DEVIATION REQUEST AND DECISION FORM

Project Name : CLOVERLEAF FILING NO. 2
Schedule No.(s) : 7124202236, 7124202239, 7123103007, 7124202238
Legal Description : SEE ATTACHED -- Exhibit B

A deviation from the standards of or in Section **ECM Ssection 3.3.1.J.2** of the Engineering Criteria Manual (ECM) is requested.

DP06 PROFILE
STA 0+00.00 TO 6+77.61

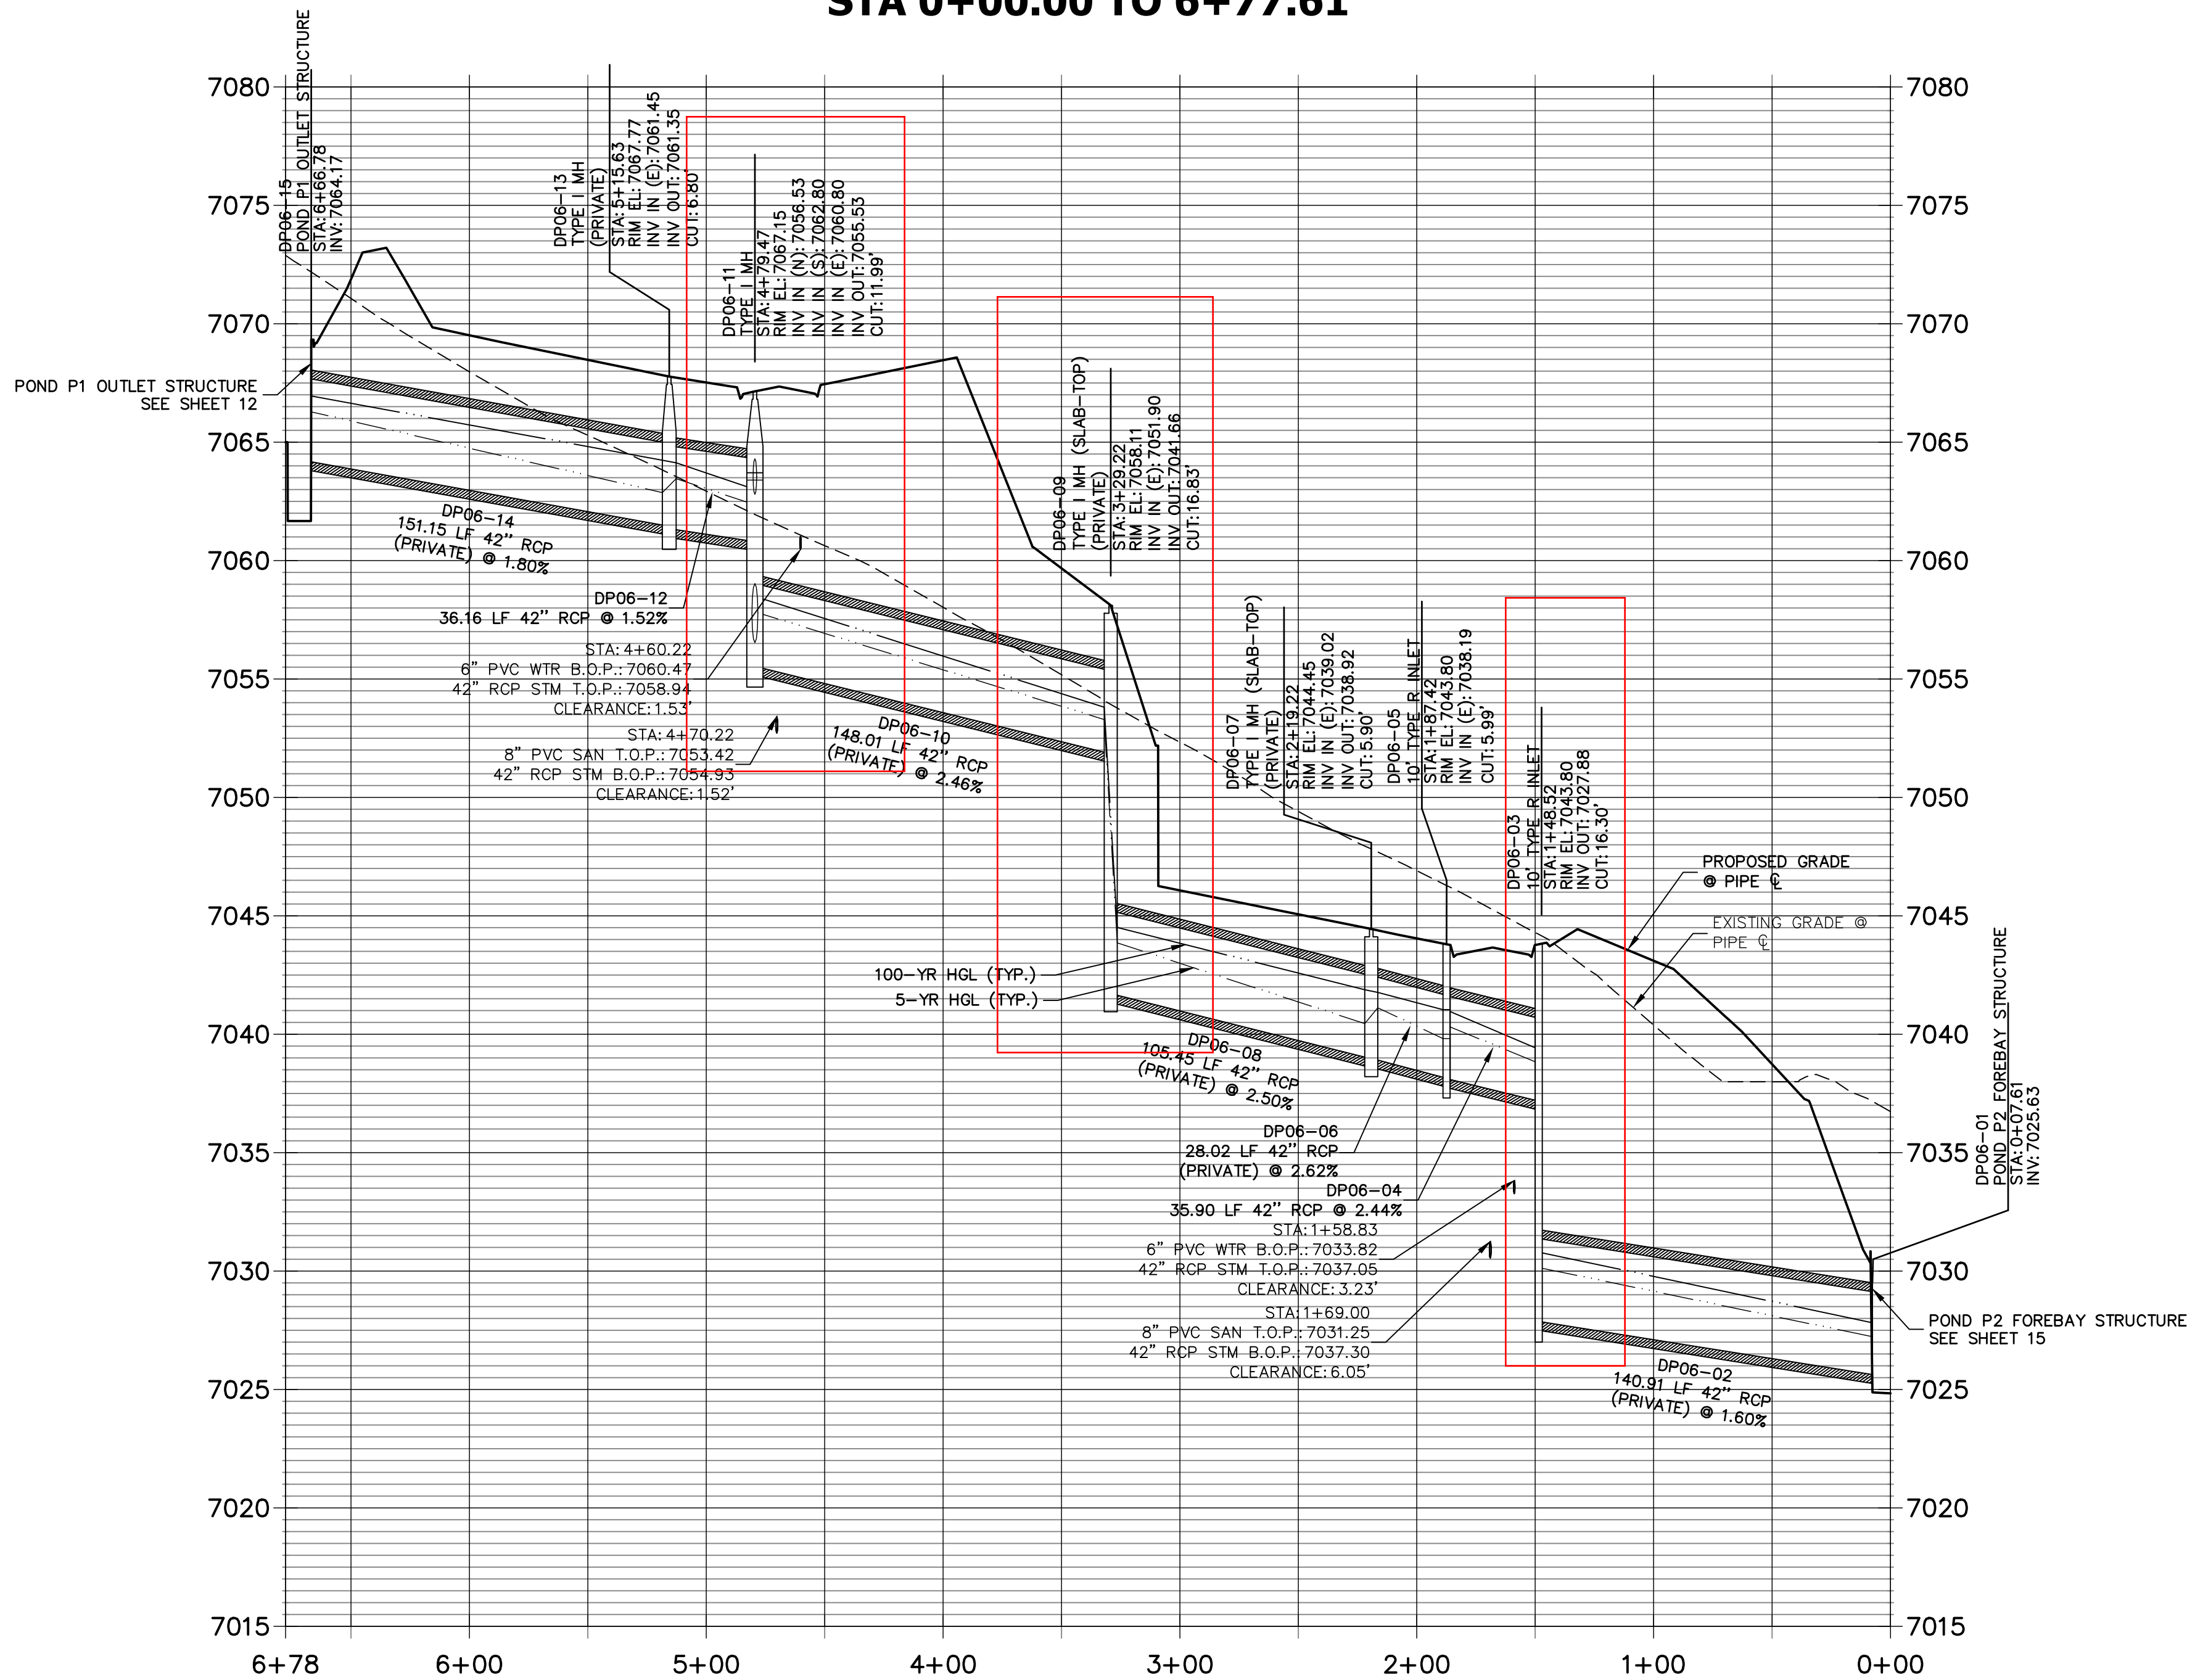
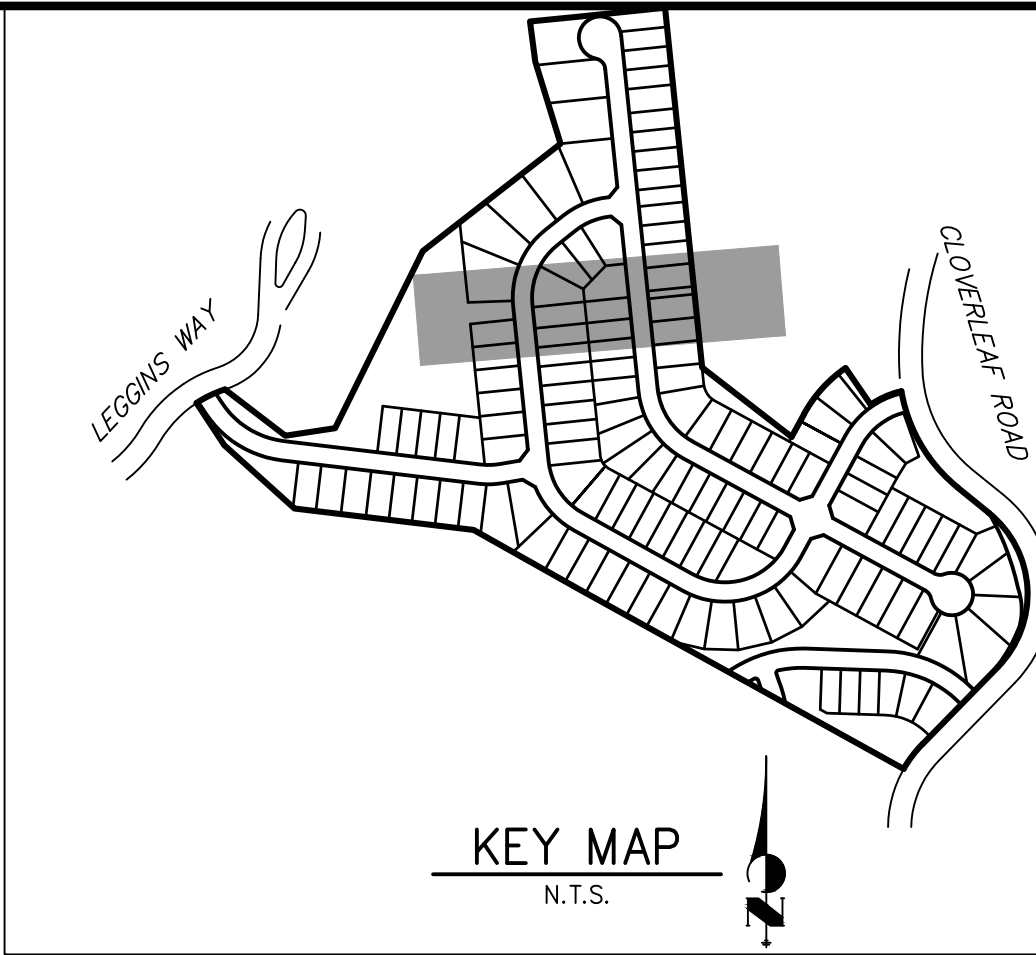
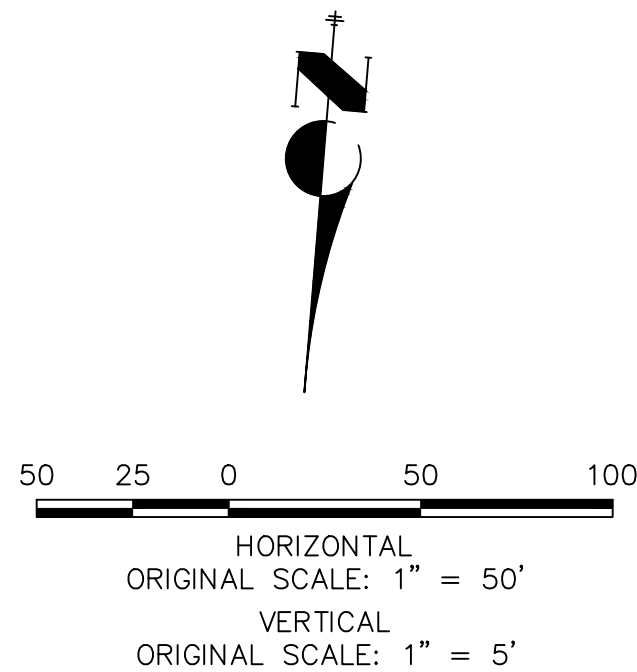
A manhole drop of greater than one foot (without matching inside top of conduit elevations) is requested in order to provide acceptable velocities within the proposed storm sewer and optimize the elevation at which the storm sewer. Slopes and associated velocities within the storm sewer system are optimized to be just below the allowable maximum velocity for the Q100 event. The requested drop manholes are vital components of this design and enable the storm system to address the natural steepness of the Clover site.

MH-DP06- 11 (5.3 ft. drop), MH-DP06-09 (10.3 ft. drop) and STR DP06-03 (Type R Inlet – 9.5 ft drop): Pond 1 to Pond 2 storm sewer. The change in grade between Pond 1 (the east offsite pond) and Pond 2 is approximately 40 feet in under 700 feet of pipe and to design the storm sewer to Section 3.3.1.J.2 would cause excessive velocities.

This request has been determined to have met the criteria for approval. A deviation from Section 3.3.1.J.2 of the ECM is hereby granted based on the justification provided.

1	CLOVERLEAF FILING 2	H-SCALE	1"=50'	No.	REVISION	BY	DATE
		V-SCALE	1"=5'				
6	STORM SEWER PLAN AND PROFILE	DATE	10/29/21				
		DESIGNED BY	APL				
28		DRAWN BY	APL				
		CHECKED BY					
JOB NO.	25158.01	SHEET	6	OF	28

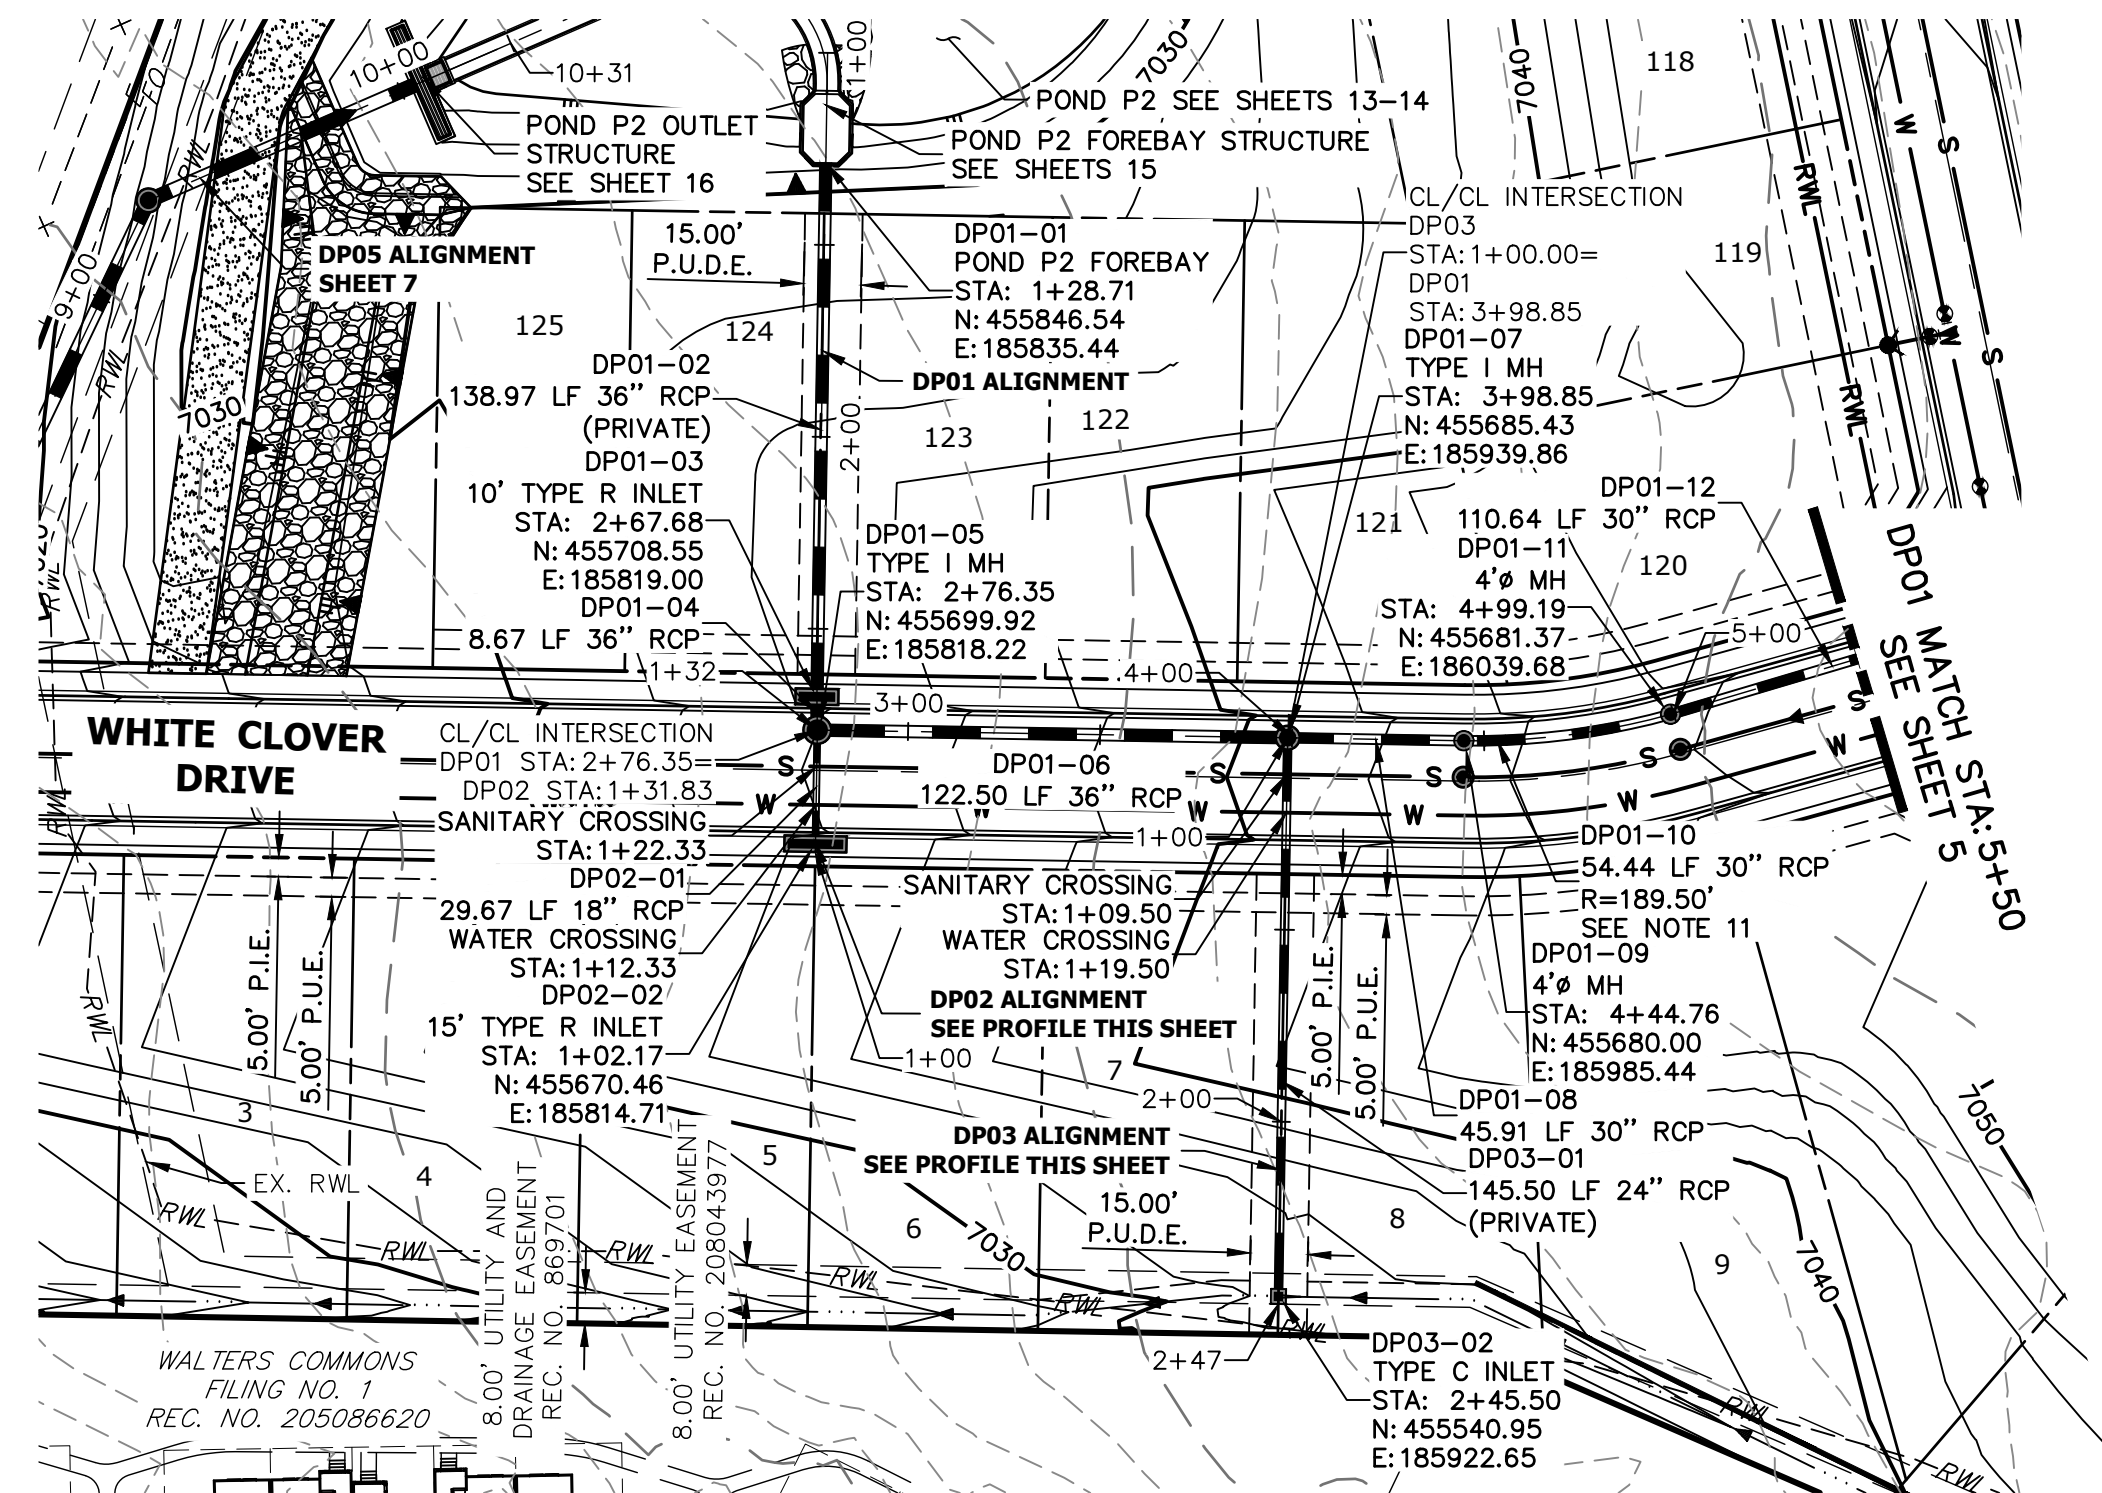
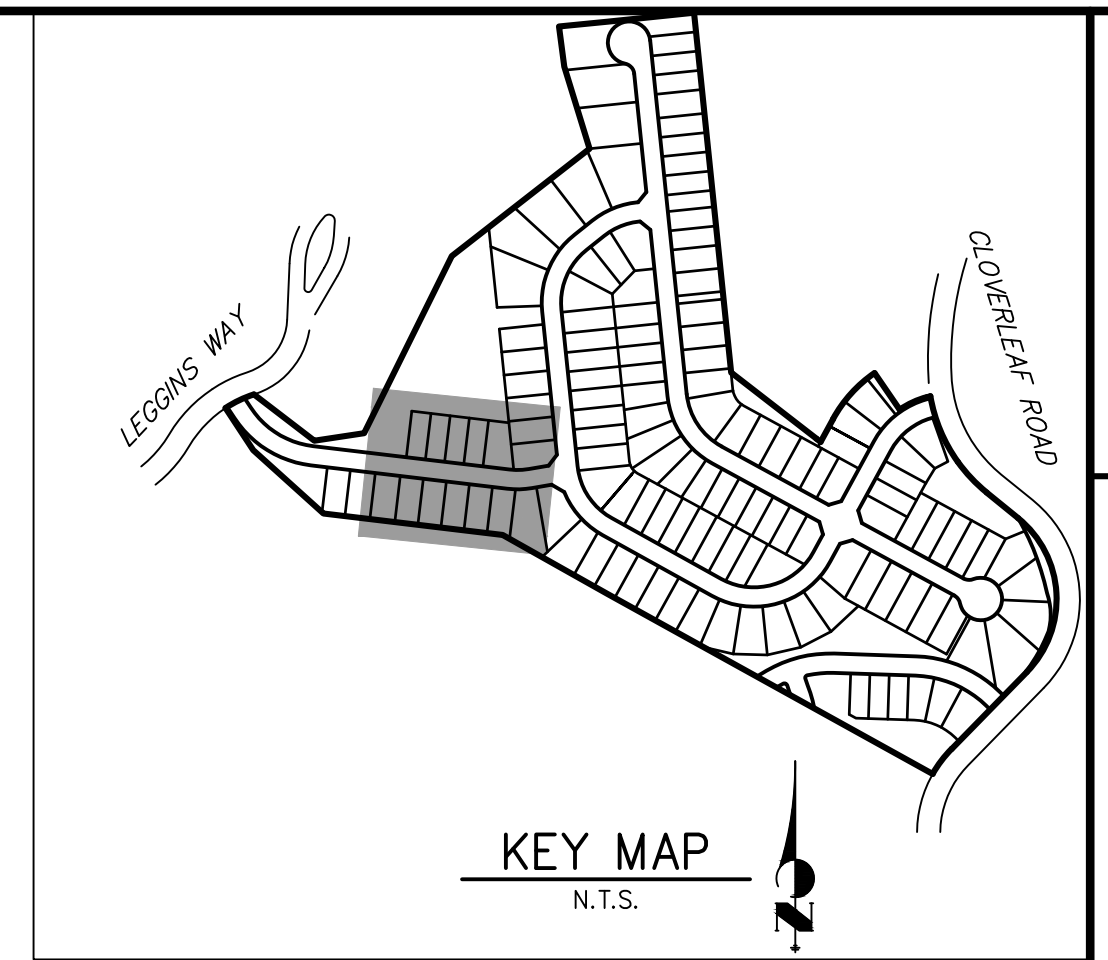
MH-DP01- 07 (6.0 ft. drop): This drop manhole is necessary collect the flows from rear yard swale along walk out lots 8-18 while allowing the White Clover Drive storm system to be at normal depths and not conflict with the sanitary sewer system.
